FERRIS - TRANSISTOR CAR RADIO - MODEL 274 (6V)

MODIFICATION - M 274 DIAL LAMP CIRCUIT (NOVEMBER 1967.)

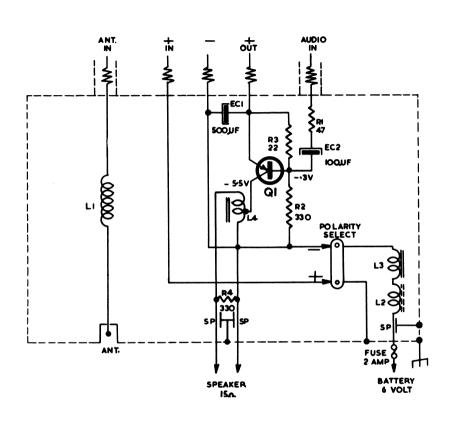
Some reports from the field indicate malfunction of the discriminator circuit which is used for solid state switching of the dial lamp. In such cases the dial lamp remains on, when the set is being used as a portable, either as a dull glow or near full brilliance, depending on degree of leakage through the AC187.

It is considered possible that some damage may occur to the AC187, by a voltage spike developed across the iron cored filter choke in cradle, if the set is removed from the cradle while still switched OM. Apparently this is done accidently by some owners, and quite deliberately by others, to retain continuity of a news item, etc., when leaving the car.

A faulty dry battery, i.e. with internal current flow to metal case, can cause leakage to develop across the AC187. Remember too, this transistor must be firmly mounted in its heat sink to avoid any possible damage.

Rather than replace a leaking AC187, the recommended modification, as in current production, is as follows:-

The insertion of a 50 volt .75 Amp Silicon Diode (EM4005), or similar, between the emitter of the discriminator and positive rail of the set, will completely offset the leakage problem - thus ensuring normal life expectancy of the dry battery.

Note: Anode of diode connects to emitter, cathode connects to positive rail. (See diagram).

The AC187 functions as a discriminator with either the emitter or collector connected to positive rail. All sets are wired with the AC187 emitter connected to positive rail, (now via the diode), as illustrated in this modification, and not with collector to positive rail as shown in the M274 Service Manual, and on printed board screening.
